STATE OF MINNESOTA
PUBLIC UTILITIES COMMISSION

In the Matter of Otter Tail Power's 2014-
2028 Integrated Resource Plan

MPUC Docket No. E017/RP-13-961

PUBLIC COMMENTS OF IZAAK WALTON LEAGUE – MIDWEST OFFICE, FRESH
ENERGY, SIERRA CLUB, AND MINNESOTA CENTER FOR
ENVIRONMENTAL ADVOCACY

Figure 1. PV Module and Component Spot Pricing¹¹

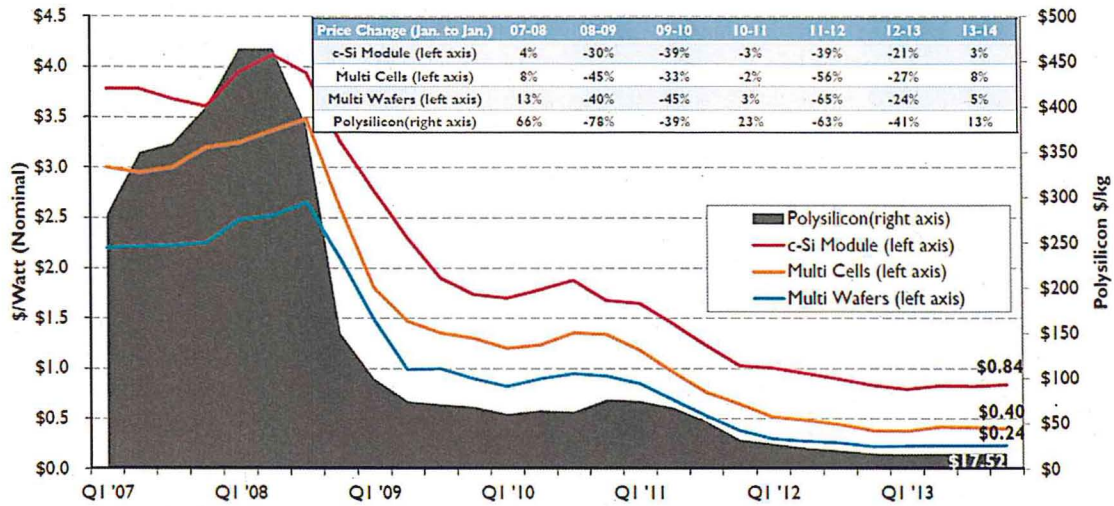
Finally, because OTP's cost escalates 3 percent per year, the real cost of solar is assumed to be rising throughout the study period.¹⁰ This is contrary to recent experience and to expectations regarding solar prices. Solar prices have come down dramatically over the past few years. For example, the National Renewable Energy Laboratory has collected data showing that crystalline silicon modules have fallen in cost from over \$4 per watt in 2008 to \$.84 per watt in late 2013/early 2014.

Given these facts, OTP should have modeled solar resources at a steady or even declining price.

Figure 2. Near-Term Price/Cost Projections¹²

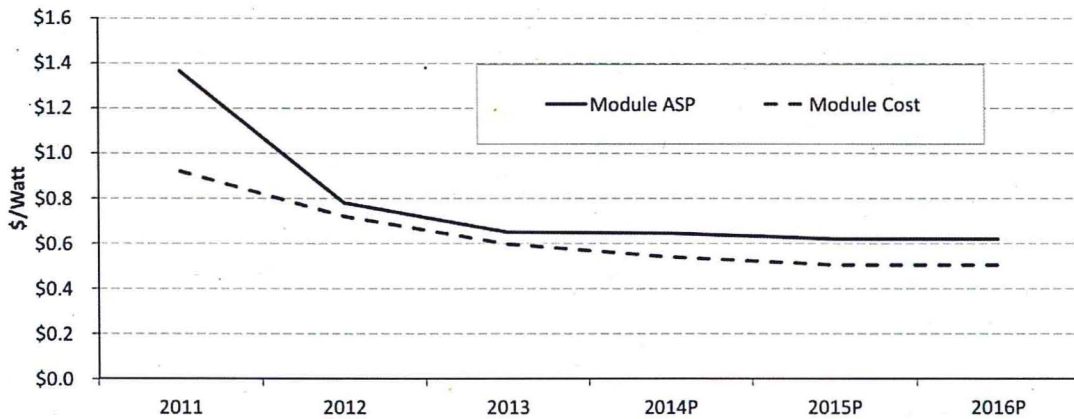
Near-term expectations are that solar prices will continue decline, though perhaps not at the pace experienced in the last few years.

Figure 3. Capacity Credit at Low Solar Penetration from LOLP-Based Studies¹⁴

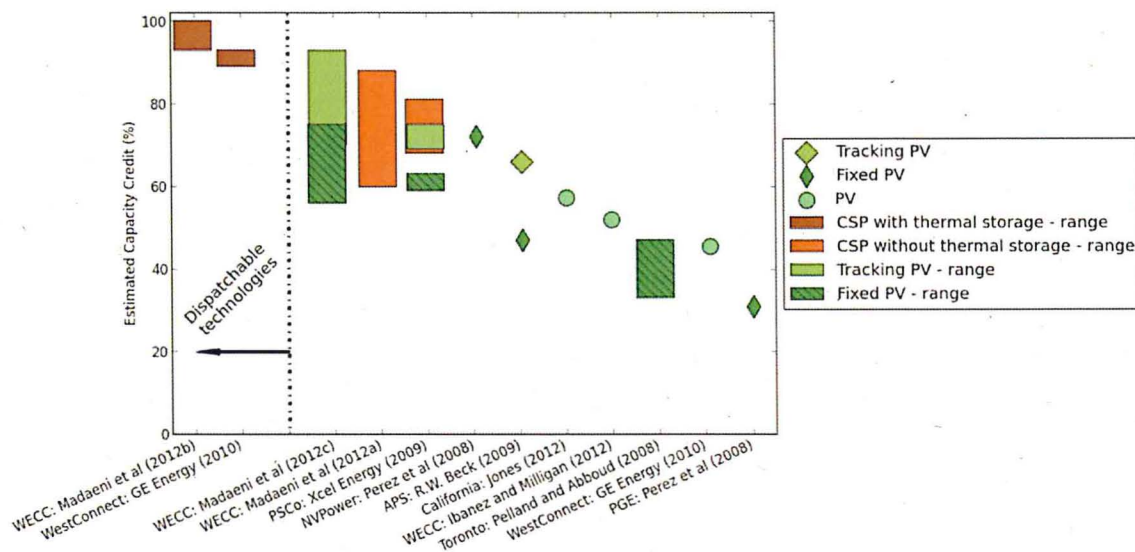
assumption.¹³ Studies looking at the capacity value of solar using a Loss of Load Probability (“LOLP”) approach have consistently accredited solar at much higher percentages. These studies are summarized in Figure 3.

OTP’s generic solar resource is assumed to be a tracking array. Tracking arrays are represented in Figure 3 with the light green diamonds and rectangles and the capacity credit of tracking systems exceeds 60 percent in all the studies listed in Figure 3—much higher than OTP’s assumed 40 percent. Clearly the specifics of any individual facility matter, but a recent Minnesota estimate is much more in line with the studies summarized in Figure 3 than with OTP’s figure. For example, in Docket No. E002/CN-12-1240, R. Thomas Beach presented testimony on behalf of Geronimo Energy showing that its distributed solar proposal could be expected to be accredited at about 71 percent of its nameplate capacity value.¹⁵

Figure 5. Four OTP Load Forecasts Filed Since January 2008¹⁸

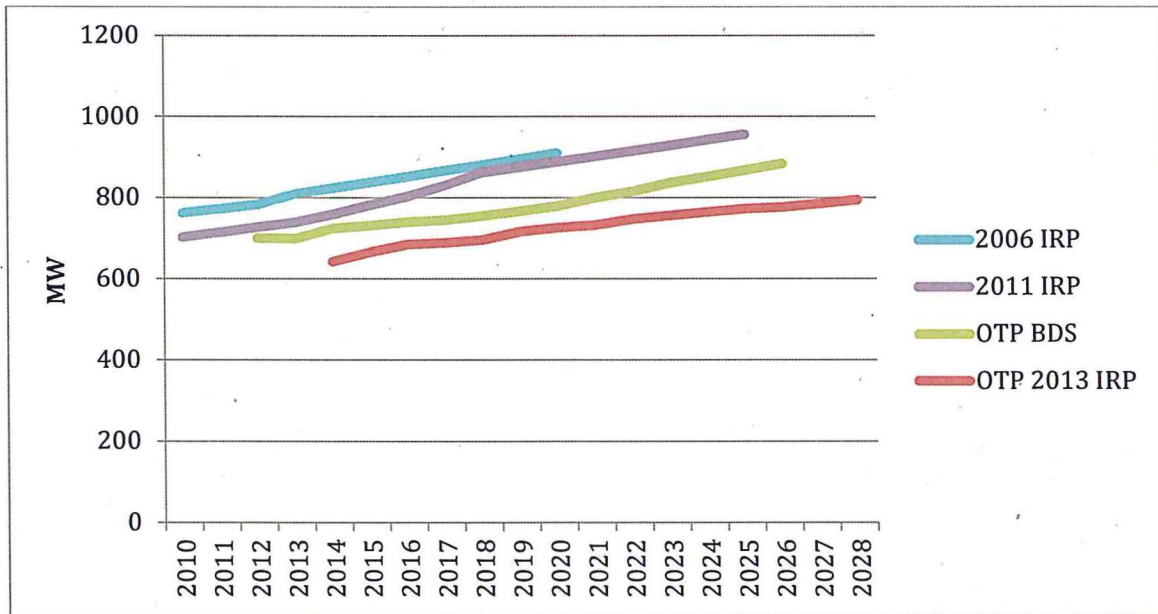
Lastly, Environmental Intervenors assert that OTP's 2013 IRP is undermined by an unreliable load forecast. Over the last several resource planning related proceedings, OTP has continued to temper expectations for its load and energy demand growth and to reduce the starting point of its load forecasts even as the rate of growth remains roughly the same. Figure 5 compares four OTP peak demand forecasts filed since January 2008.

The bottom line is that OTP continues to overestimate its load forecast. In light of evidence prior forecasts overestimated energy needs, OTP should be required to consider the effect of efficiency measures such as increasingly stringent building codes and appliance efficiency standards when estimating its load forecast.
